Former ASARCO East Helena Facility Interim Measures Work Plan— Conceptual Overview of Proposed Interim Measures and Details of 2012 Activities

Prepared for
The Montana Environmental Trust Group, LLC
Trustee of the Montana Environmental Custodial Trust

Revised September 2012

- **Appendix C** contains public comments on the June 2012 draft *Former ASARCO East Helena Facility Interim Measures Work Plan—Conceptual Overview of Proposed Interim Measures and Details of 2012 Activities*, followed by USEPA responses. Comments were received from the Lewis and Clark County Water Quality Protection District, James Schell, the Lewis and Clark City-County Health Department, and the State of Montana (Montana Department of Justice and Montana Department of Environmental Quality).

FIGURE 2-7
Potentiometric Map
Interim Measures Work Plan—2012 Draft
East Helena, Montana

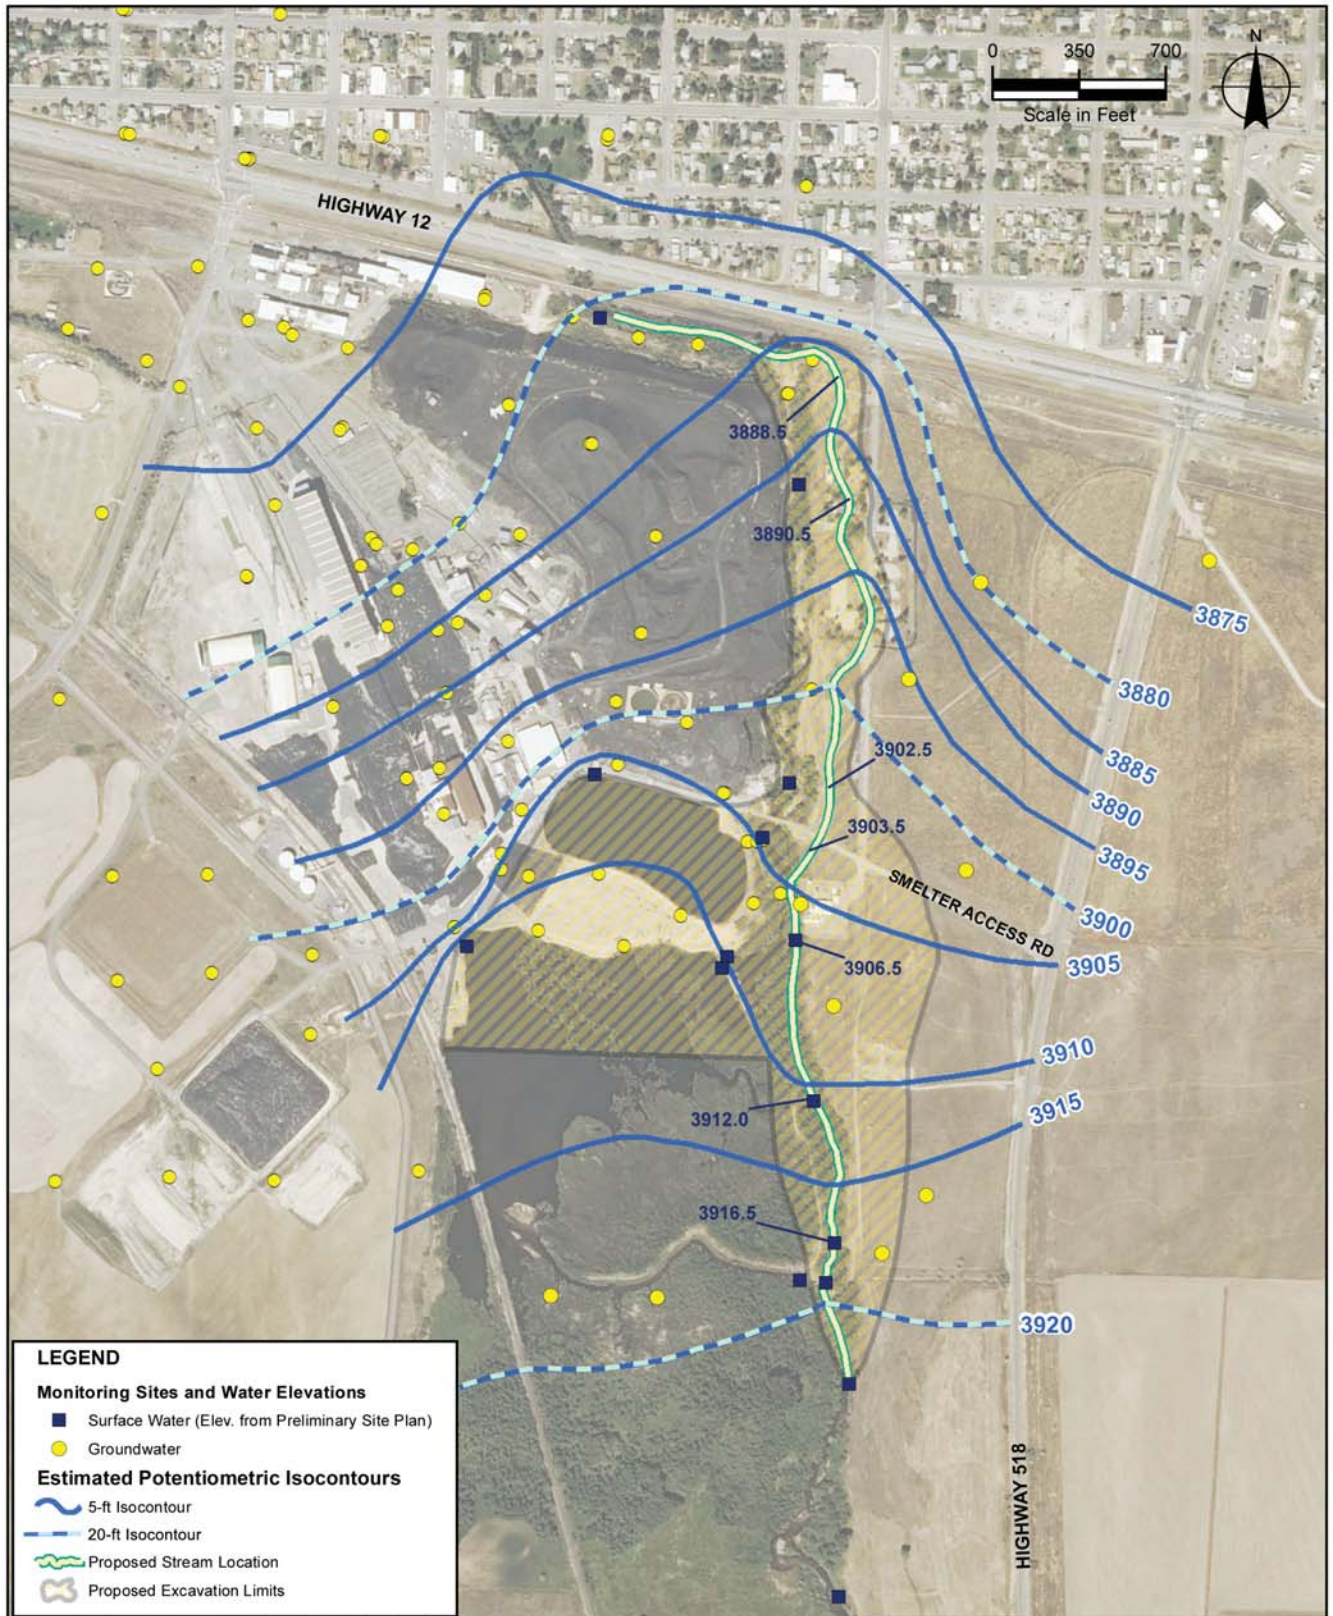
While Figure 2-7 and Figure 2-8 outline dated and estimated potentiometric mapping for November, I believe a statement and/or data regarding analysis of high water months should also be included.

FIGURE 2-8
Estimated Potentiometric Surface Post-PPC
Reclamation/Tito Park Removal and Regrading
Interim Measures Work Plan-2012 Draft
East Helena, Montana

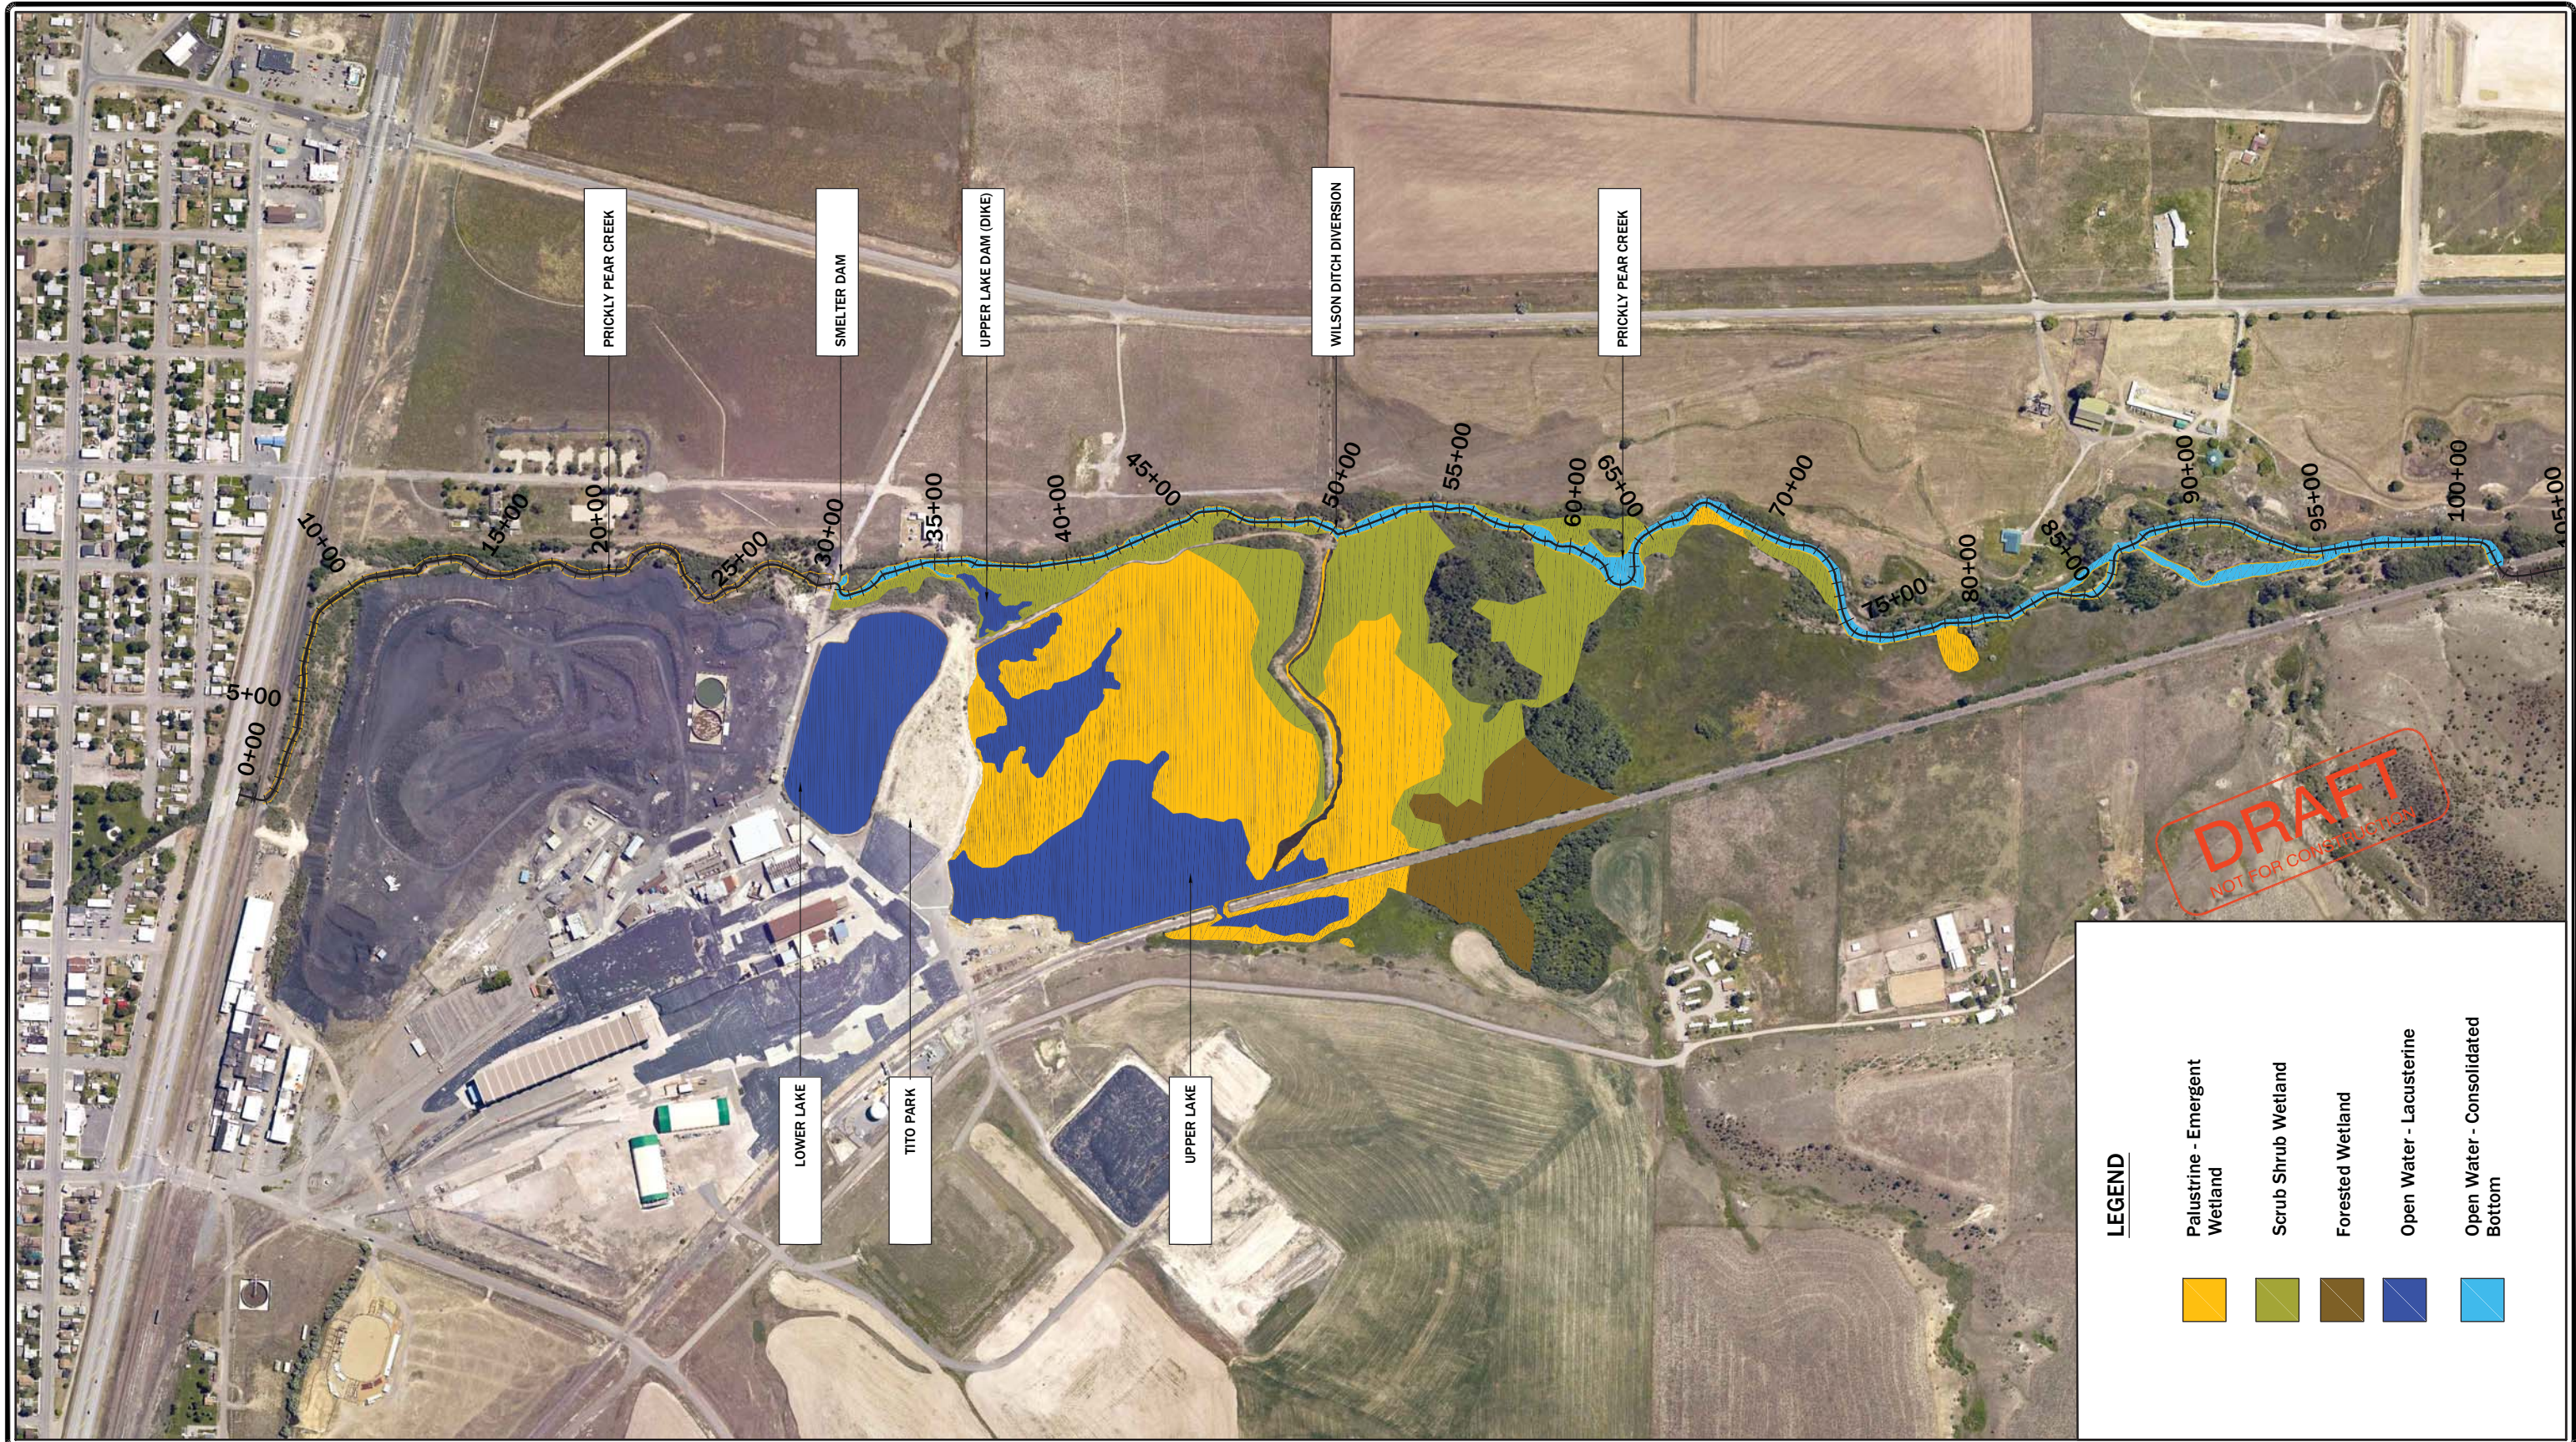
19. Figure 2-8 indicates the expected potentiometric surface after initiation of the SPHC. The methods used to complete this figure are not explained. The use of the figure is misleading, since there is no way to predict the impacts of SPHC without using a properly calibrated numerical model which accounts for all components of the hydrologic system.
